S E R V I C E N O T E

37717C PDH/SDH/Jitter Test Set

Instrument Fails to Download Firmware via Floppy disk

DATE: March 1997

Figure 2 - Showing the Wire-Link modification to the Processor Board

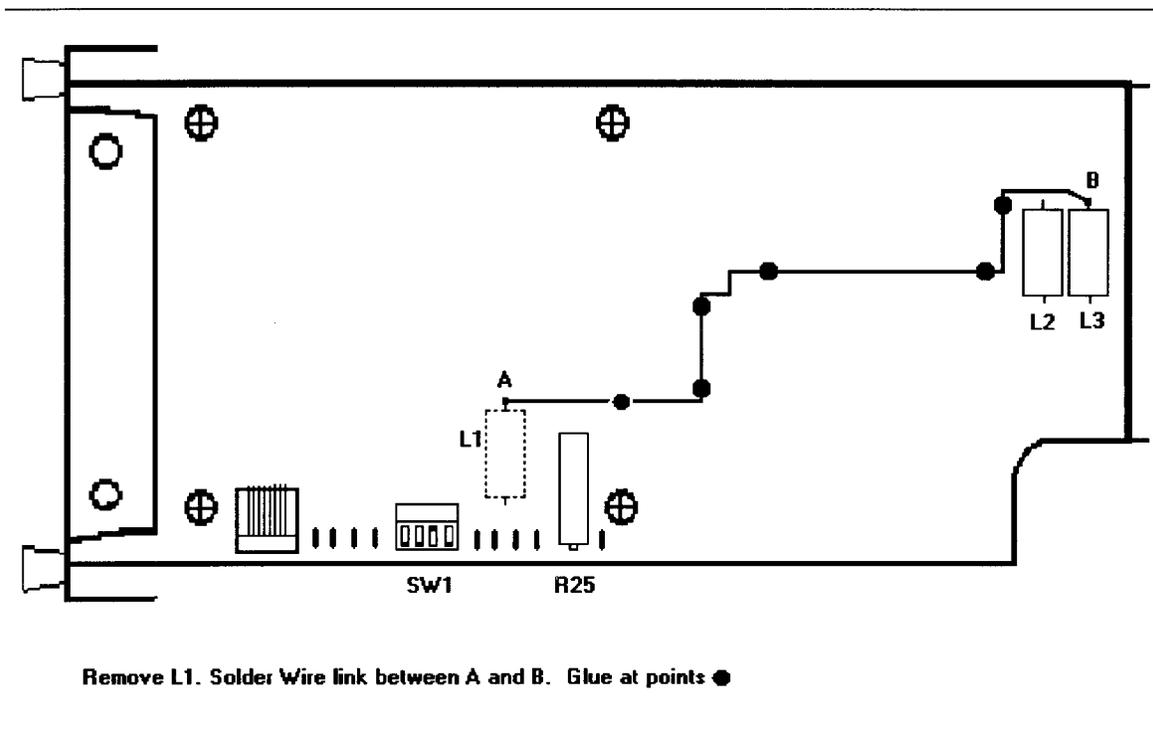
A wire-link modification to the processor PCB to improve the stability of the disk-drive supply voltage should also be done on these units. This modification was introduced at BS 2:65.

1. Remove the processor module as described above.
2. Remove L1 and discard - see Figure 2..
3. Solder a wire link on the topside of the board as shown in Figure 2.
4. Using an epoxy resin glue, support the wire link at the points shown in Figure 2.

If any 37717C unit with Build Status between 1:14 and 2:64 (inclusive) is encountered, carry out the wire-link modification to the processor PCB as described below.

Figure 3 Processor Module (viewed from top)

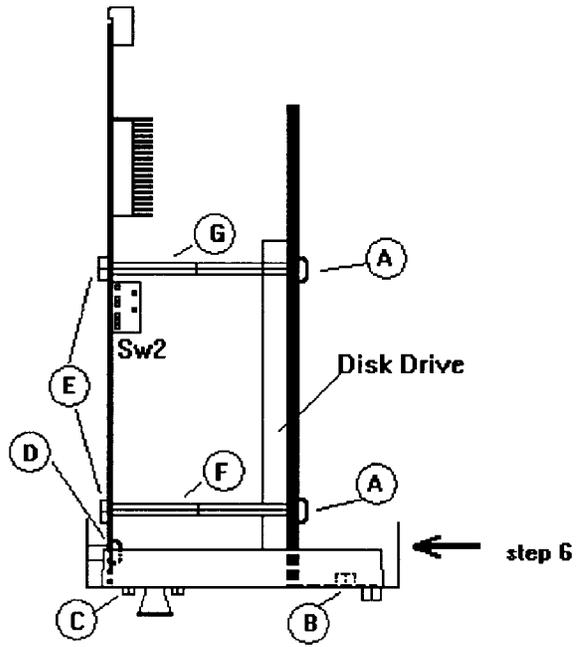
In addition, if the Build Status is between 1:14 and 1:31 (inclusive), order the special Screened disk-drive Assembly Kit and fit this by following the procedure below. This specially screened disk drive is more resistant to PSU generated RFI and will prevent the corruption of data which causes the downloading problem to occur.

1. Unscrew the four posidrive screws which secure the Disk Drive with it's metal shield to the disk-drive supports on the CPU Board (Figure 3 item A).
2. Unscrew the nut which secures the Disk Drive to the CPU module front panel (Figure 3 item B).

8. Unscrew the nuts (Figure 3 item E) securing the four disk-drive supports to the CPU Board. Discard these supports (Figure 3 items F and G).
9. Fit the two new supports from the kit in the rear two support holes only (Figure 3 item G).
